737

Service Bulletin

Number: 737-57-1320
Original Issue: October 07, 2016
ATA System: 5700

SUBJECT: WINGS - Trailing Edge - Tank Access Door - Replacement

**FIGURE 1: LEFT WING - DOUBLER SURFACE - PREPARE FOR ELECTRICAL BOND AND APPLY NEW PRIMER
(SHEET 1 OF 3)**

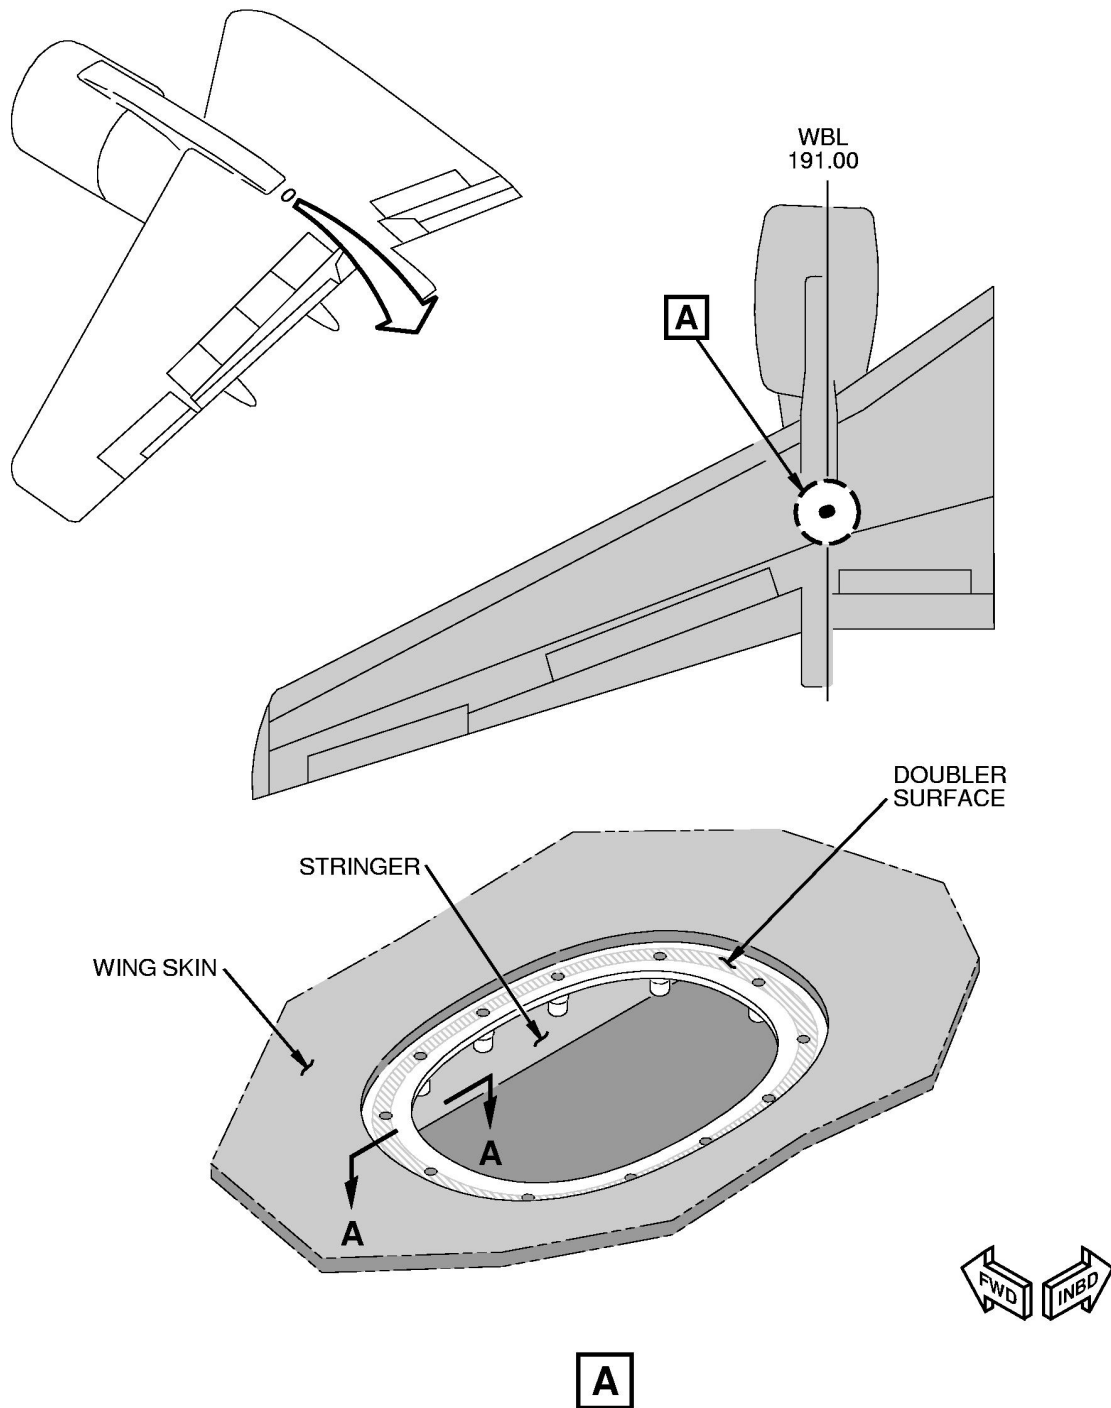
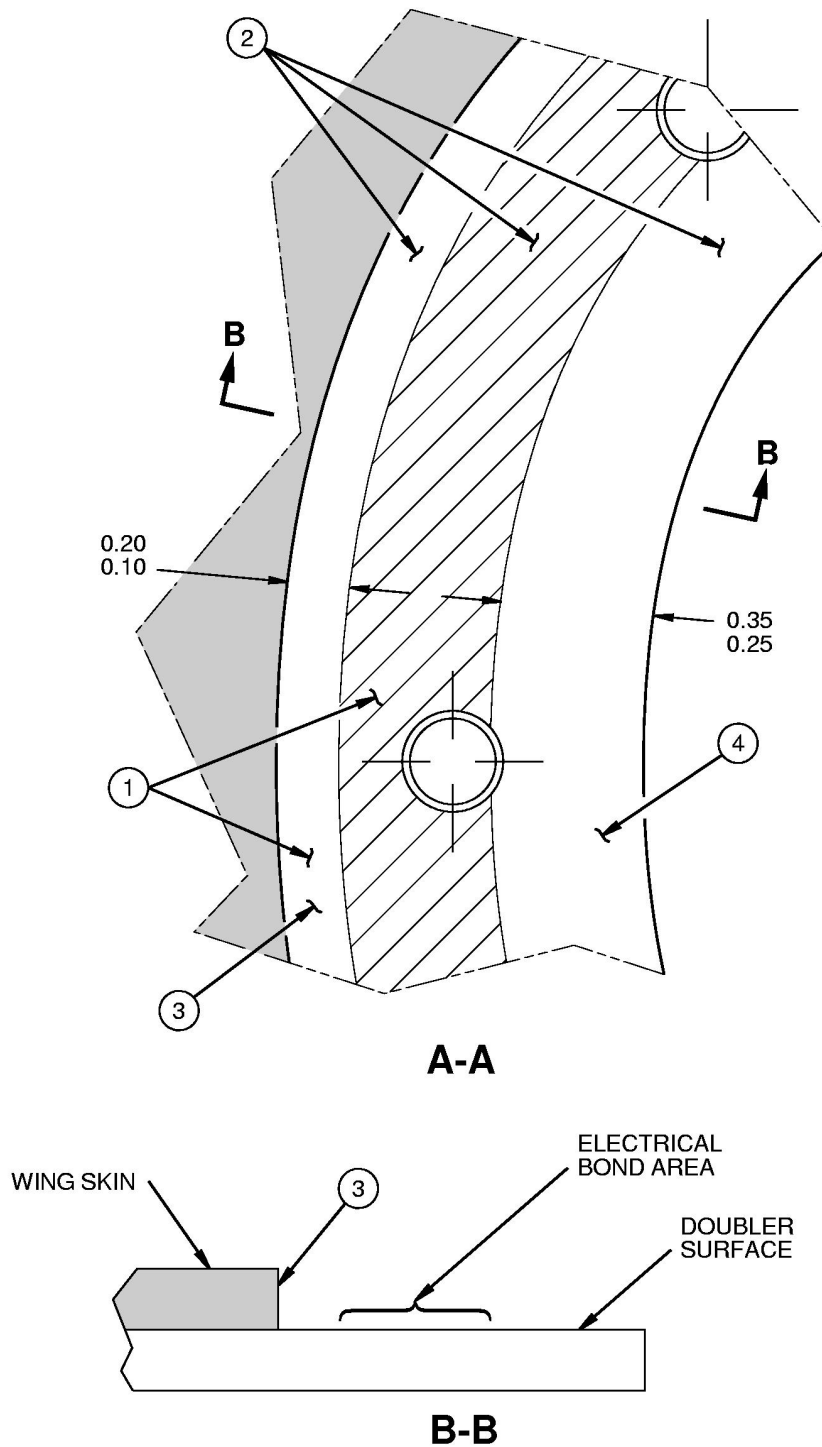
1. RC - Prepare the surface of the doubler that mates with the door assembly for a doubler-to-door assembly electrical bond, and apply new primer.
 - a. Left Wing - Do the work in accordance with FIGURE 1.
 - b. Right Wing - Do the work in accordance with FIGURE 2.
2. RC - Cap seal the nutplates that attach to the door assembly bolts.

| Step | Task | Name | Identification | Qty | More Data |
|--|-------|-----------------------------|------------------------------------|--------|--|
| (a) Remove corrosion resistant finish and the anodic film (Anodize, Iridite, Alodine, etc.,) from the surface in the area shown along the entire circumference of the doubler. | | | | | |

**FIGURE 2: RIGHT WING - DOUBLER SURFACE - PREPARE FOR ELECTRICAL BOND AND APPLY NEW PRIMER
(SHEET 1 OF 3)**

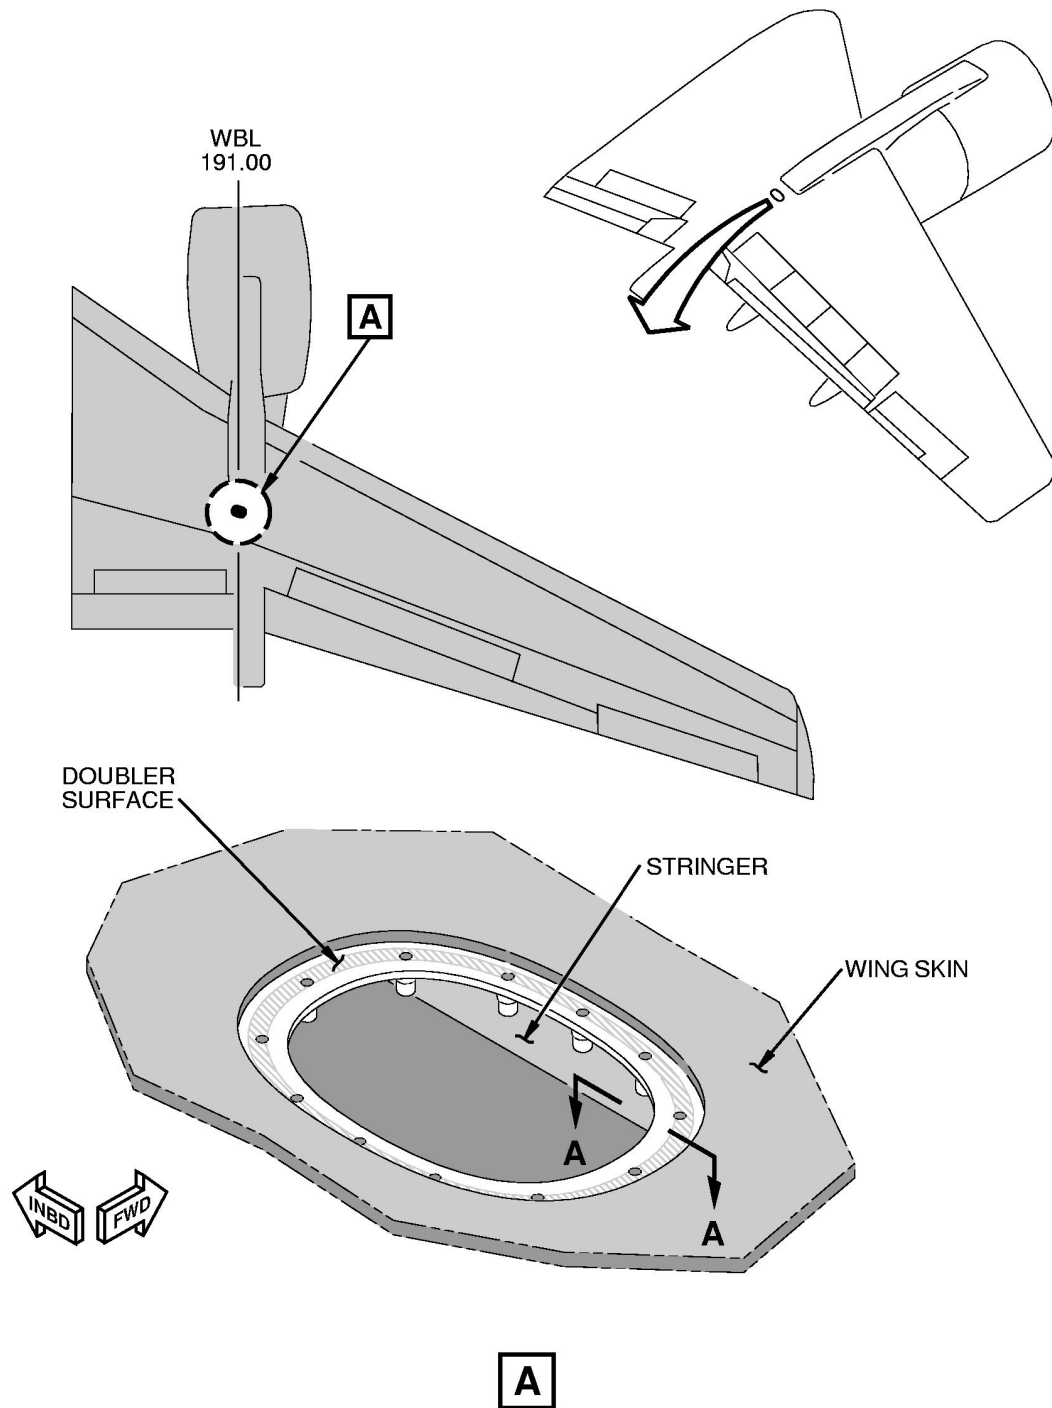
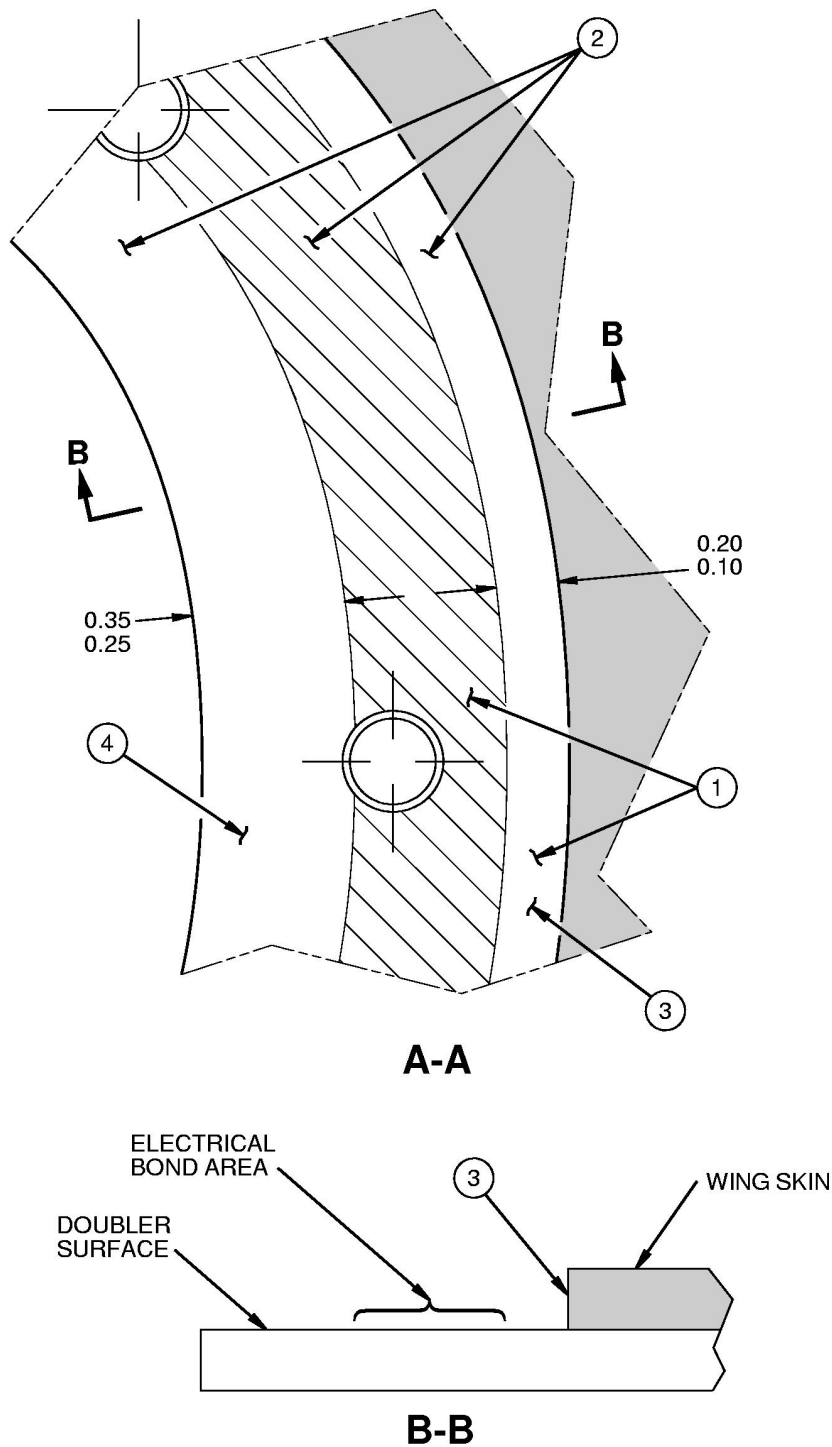
| Step | Task | Name | Identification | Qty | More Data |
|--|-------|-----------------------------|------------------------------------|--------|--|
| (a) Remove corrosion resistant finish and the anodic film (Anodize, Iridite, Alodine, etc.,) from the surface in the area shown along the entire circumference of the doubler. | | | | | |

**FIGURE 3: LEFT WING - DOUBLER - CAP SEAL NUTPLATES
(SHEET 1 OF 4)**

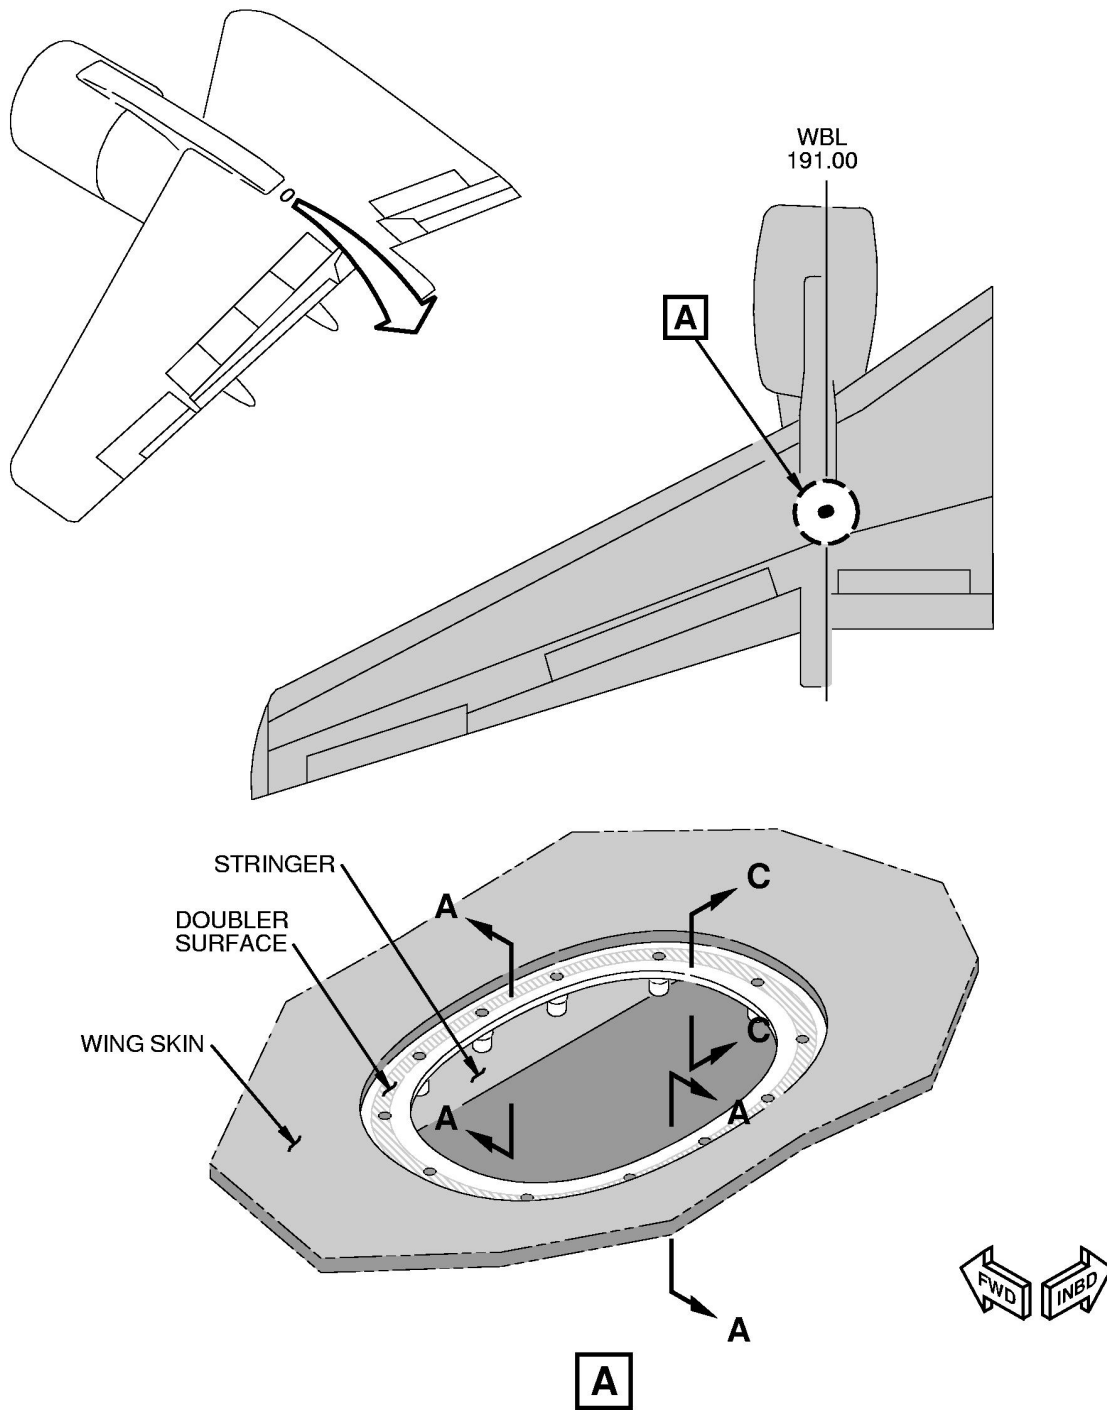
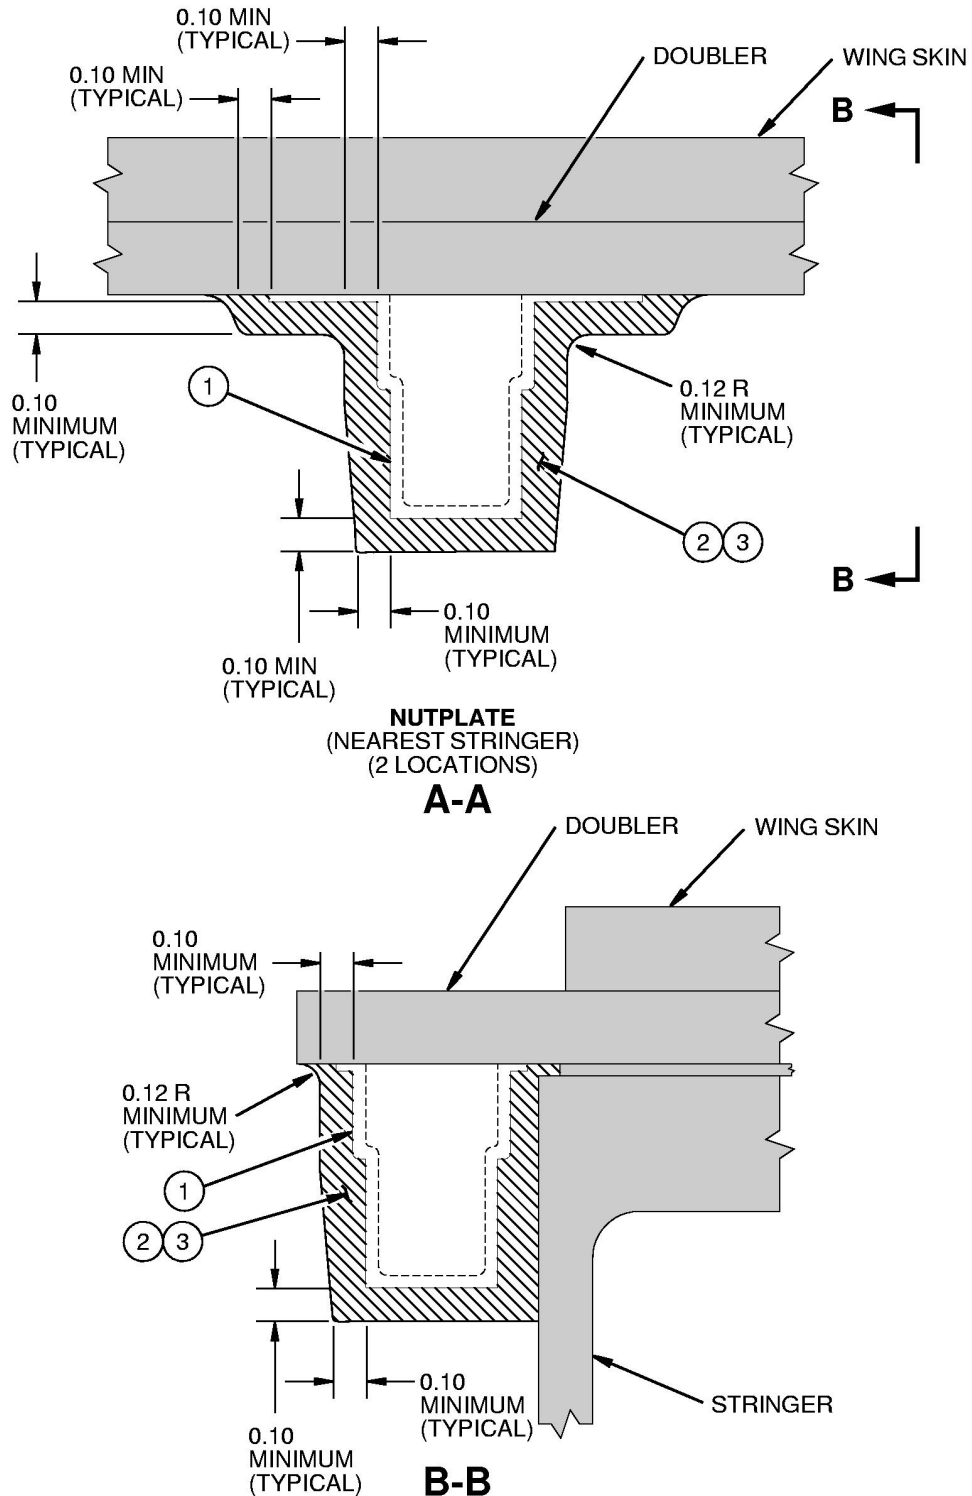
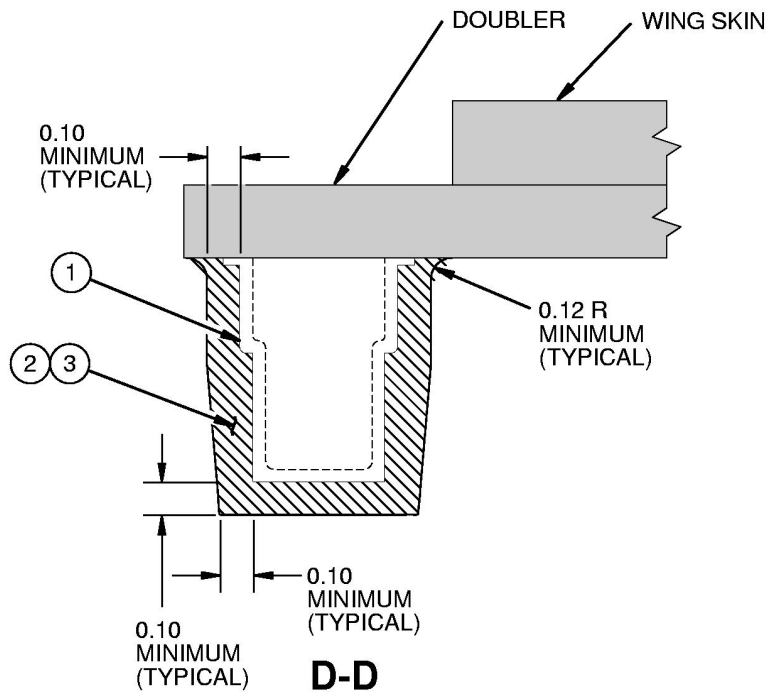
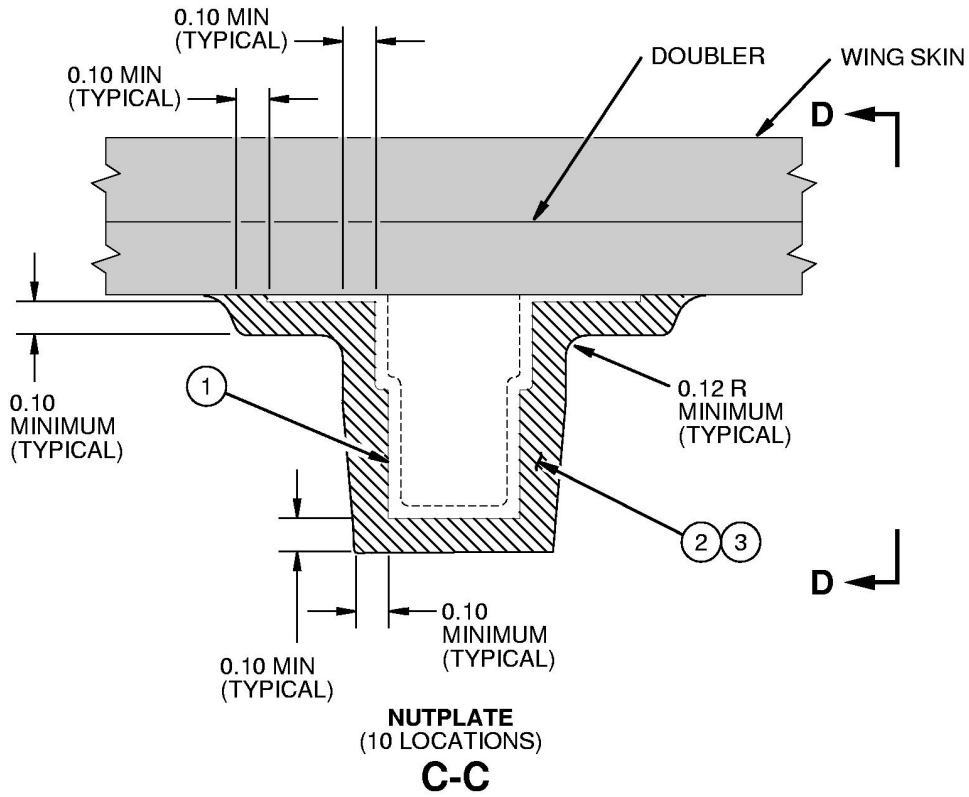
- a. Left Wing - Do the work in accordance with FIGURE 3.
 - b. Right Wing - Do the work in accordance with FIGURE 4
3. RC - Install the new door assemblies at WBL 191.00.
 - a. Left Wing
 - (1) Install the new door assembly 8117L with a wire mesh gasket and bolts in accordance with FIGURE 5.
 - (2) Measure the door assembly -to- wing skin electrical bond in accordance with FIGURE 5.
 - (a) The electrical bond check is complete if the maximum resistance is 0.0025 ohm (2.5 milliohm) or less.
 - (b) If the maximum resistance value is NOT 0.0025 ohm (2.5 milliohm) or less.
 - 1) Temporarily remove the parts that were installed in accordance with FIGURE 5.

| Step | Task | Name | Identification | Qty | More Data |
|--|-------|----------|-------------------|--------|--|
| (b) Move the sealant with a sealant fairing tool to get the minimum dimensions shown in this figure. | | | | | |
